Stage 03: Report to the Authority

Grid Code

GC0062 – Fault Ride Through

01	Workgroup Report
02	Industry Consultation
03	Report to the Authority

Figure 5.15(a) – Final Proposed Mode B Voltage Duration Curve.

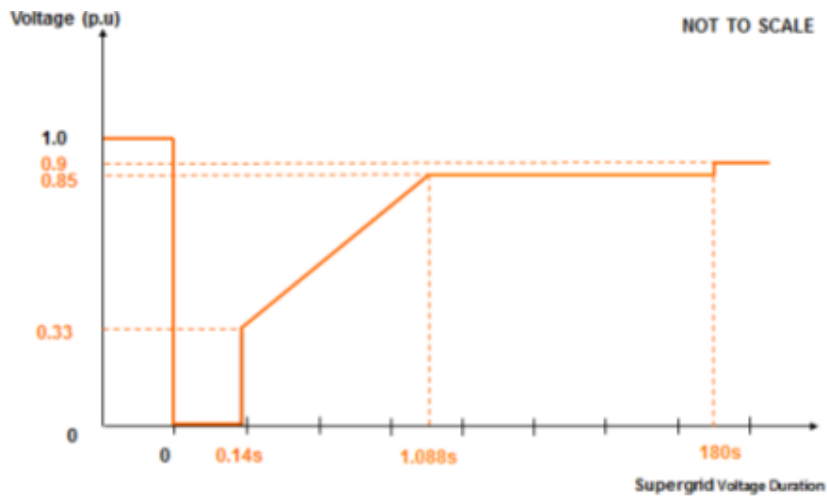
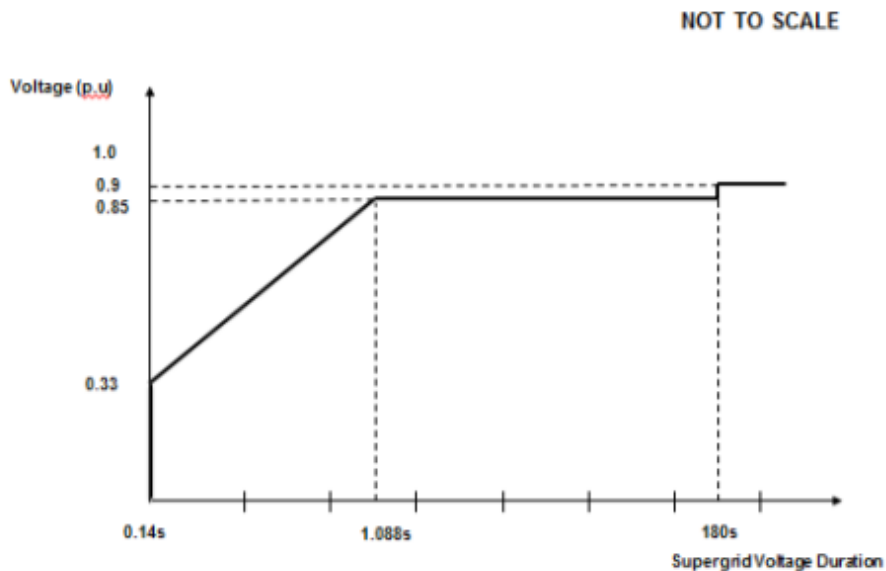
- 5.14 These studies resulted in the need to refine the proposed voltage duration curve further resulting in the development of Option 3. Option 4 (a revision of Option 3) was also investigated by extending the time at which the voltage recovers to 0.85 p.u to 1.5 seconds. This also resulted in instability as it transgressed the critical point of 0.5p.u at 450ms. These results are shown in Figure 5.14 where Option 4 is shown as proposal 2 in Figure 5.14. These results were run were run by a Workgroup member and also consistent with the results obtained by National Grid. A full summary of these results together with sensitivities to fault level and voltage are covered in Appendix 1 of this Consultation document.

- 5.15 The results from these studies (and the corresponding evidence shown in Appendix 1) show that Proposal 1 which is equivalent to Option 3 shown in Figure 5.11 above clearly, demonstrate this to be the optimum requirement. Further analysis was also conducted where Generators under test were subject to long duration voltage dips

were the retained voltage was in the order of 0.85p.u for a period of 180 seconds (3minutes). Under these scenario's, generator stability was observed. Taking these results into account, then enables the voltage duration curve to be finalised as shown in Figure 5.15(a) which removing the 140ms period results in Figure 5.15(b) below.

Figure 5a

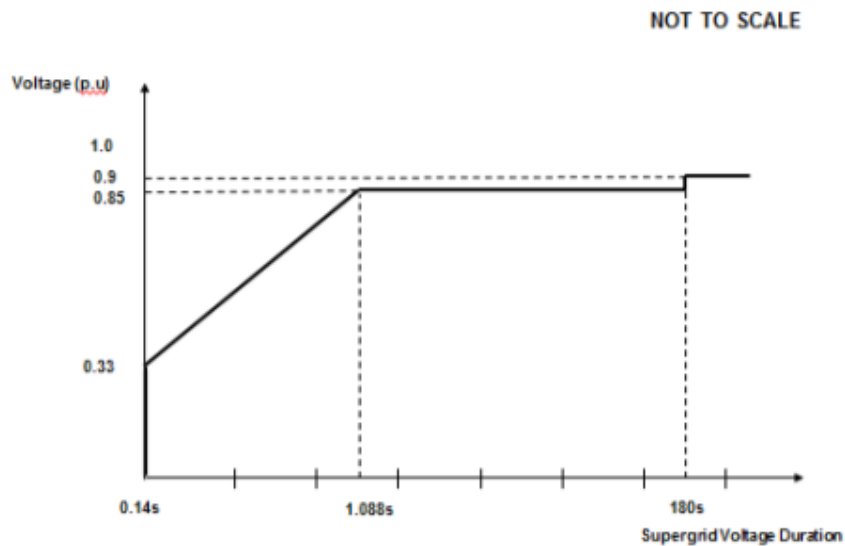
- (i) remain transiently stable and connected to the **System** without tripping of any **Synchronous Generating Unit** for balanced **Supergrid Voltage** dips and associated durations on the **Onshore Transmission System** (which could be at the **Interface Point**) anywhere on or above the heavy black line shown in Figure 5a. Appendix 4A and Figures CC.A.4A.3.2 (a), (b) and (c) provide an explanation and illustrations of Figure 5a; and,

- (ii) provide **Active Power** output at the **Grid Entry Point**, during **Supergrid Voltage** dips on the **Onshore Transmission System** as described in Figure 5a, at least in proportion to the retained balanced voltage at the **Onshore Grid Entry Point** (for **Onshore Synchronous Generating Units**) or **Interface Point** (for **Offshore Synchronous Generating Units**) (or the retained balanced voltage at the **User System Entry Point** if **Embedded**) and shall generate maximum reactive current (where the voltage at the **Grid Entry Point** is outside the limits specified in CC.6.1.4) without exceeding the transient rating limits of the **Synchronous Generating Unit** and,

- (iii) restore **Active Power** output following **Supergrid Voltage** dips on the **Onshore Transmission System** as described in Figure 5a, within 1 second of restoration of the voltage to 1.0p.u of the

Figure 7b

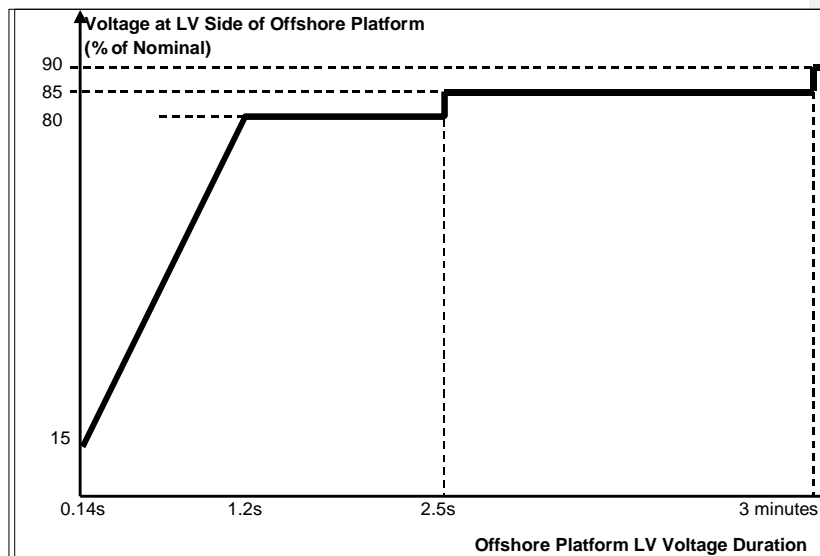
- (i) remain transiently stable and connected to the System without tripping of any ~~Offshore Generating Unit or Offshore Power Park Module~~ and / or any constituent Power Park Unit, for any balanced voltage dips on the LV side of the Offshore Platform and associated durations anywhere on or above the heavy black line shown in Figure 7b. Appendix 4B and Figures CC.A.4B.5. (a), (b) and (c) provide an explanation and illustrations of Figure 7b. It should be noted that in the case of an ~~Offshore Generating Unit, or Offshore Power Park Module~~ (including any Offshore Power Park Unit thereof) which is connected to an Offshore Transmission System which includes a Transmission DC

- (ii) provide **Active Power** output, during voltage dips on the **LV Side of the Offshore Platform** as described in Figure 7b, at least in proportion to the retained balanced or unbalanced voltage at the **LV Side of the Offshore Platform** except in the case of an **Offshore Non-Synchronous Generating Unit** or **Offshore Power Park Module** where there has been a reduction in the **Intermittent Power Source** in the time range in Figure 7b that restricts the **Active Power** output below this level and shall generate maximum reactive current (where the voltage at the **Offshore Grid Entry Point** is outside the limits specified in CC.6.1.4) without exceeding the transient rating limits of the ~~Offshore Generating Unit or~~ **Offshore Power Park Module** and any constituent **Power Park Unit**; and,

- (iii) within 1 second of the restoration of the voltage at the **LV Side of the Offshore Platform** (to the minimum levels specified in CC.6.1.4) restore **Active Power** to at least 90% of the ~~Offshore Generating Unit's or~~ **Offshore Power Park Module's** immediate pre-disturbed value, unless there has been a reduction in the **Intermittent Power Source** in the time range in Figure 7b that restricts the **Active Power** output below this level. Once the **Active Power** output has been restored to the required level, **Active Power** oscillations shall be acceptable provided that:

Figure CC.A.4A3.1

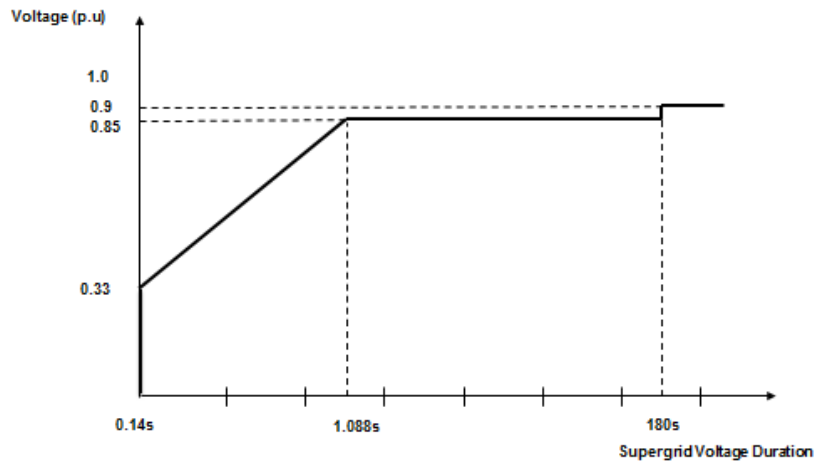
For balanced Supergrid Voltage dips on the Onshore Transmission System having durations greater than 140ms and up to 3 minutes, the fault ride through requirement is defined in CC.6.3.15.1 (1b) and Figure 5a which is reproduced in this Appendix as Figure CC.A.4A3.1 and termed the voltage-duration profile.

Figure CC.A.4A3.32.2

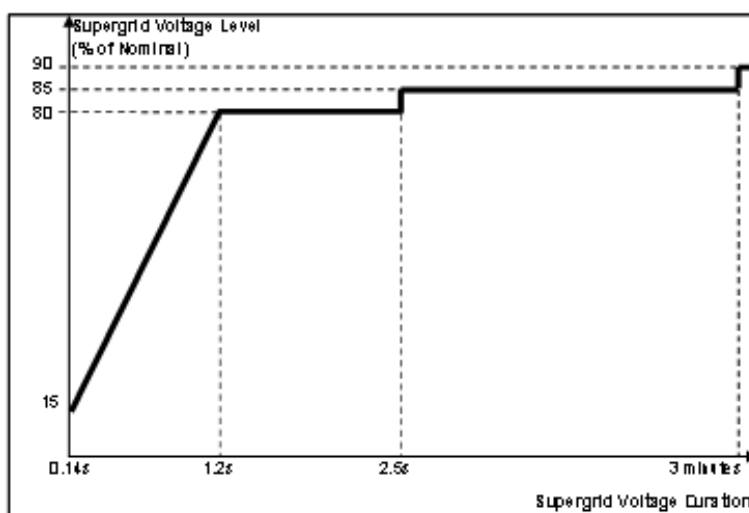
For balanced **Supergrid Voltage** dips on the **Onshore Transmission System** (which could be at an **Interface Point**) having durations greater than 140ms and up to 3 minutes the fault ride through requirement is defined in CC.6.3.15.1 (2b) and Figure 5b which is reproduced in this Appendix as Figure CC.A.4A3.32 and termed the voltage-duration profile.

Figures CC.A.4A.3.43 (a), (b) and (c) illustrate the meaning of the voltage-duration profile for voltage dips having durations greater than 140ms.

Figure CC.A.4B3.1

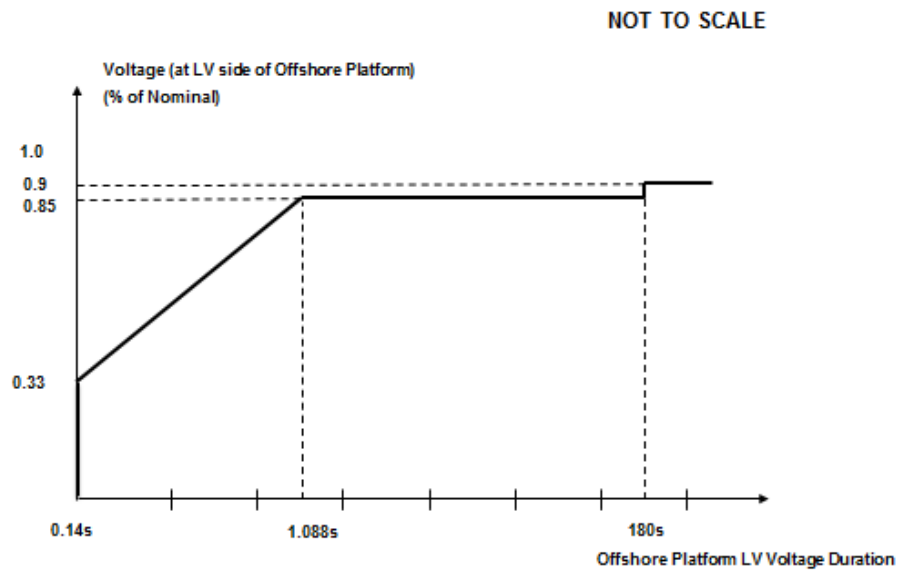
In addition to CC.A.4B.2 the fault ride through requirements applicable to **Offshore Synchronous Generating Units** during balanced voltage dips which occur at the **LV Side of the Offshore Platform** and having durations greater than 140ms and up to 3 minutes are defined in CC.6.3.15.2 (1b) and Figure 7a which is reproduced in this Appendix as Figure CC.A.4B3.1 and termed the voltage-duration profile.

Figure CC.A.4B.43

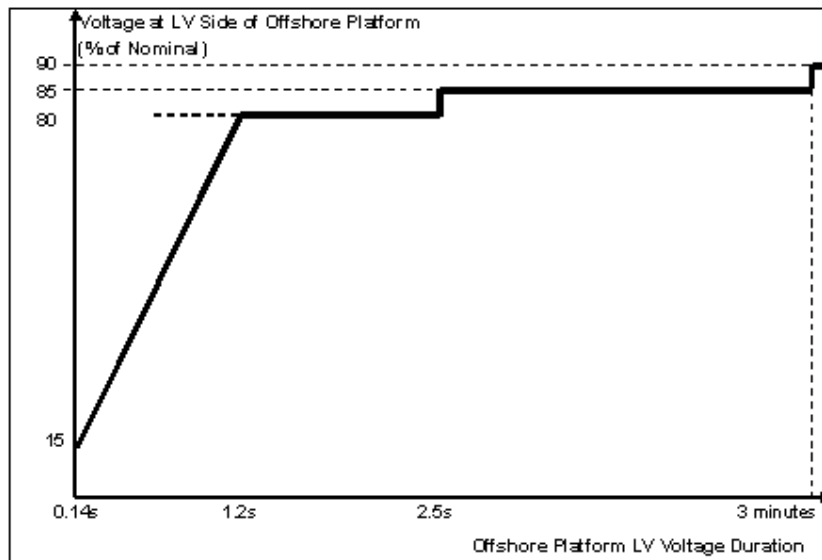
In addition to CCA.4B.2 the fault ride through requirements applicable for ~~Offshore Generating Units, and~~ **Offshore Power Park Modules** during balanced voltage dips which occur at the **LV Side of the Offshore Platform** and have durations greater than 140ms and up to 3 minutes are defined in CC.6.3.15.2 (2b) (i) and Figure 7b which is reproduced in this Appendix as Figure CC.A.4B.43 and termed the voltage-duration profile.
